## *Stannah Lifts Technical Bulletin.*

**Issue No: M36.**

### *LIFT TYPE: - Stannah Midilift SL Vertical Platform Lift.*

Correct Installation of 1 hour fire rated door.

#### **Fire Door and Frame**

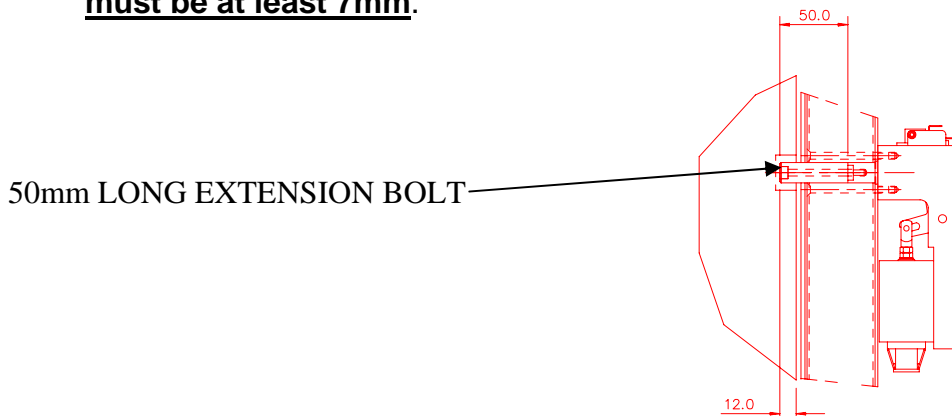
The door itself is noticeably different from the standard door in that it has two 15mm wide grooves around the sides for intumescent strips and is thicker at 54mm. The door is also 5kg heavier (80kg) than the standard fire door.

The door frame is 60mm wide which is 10mm wider than standard.
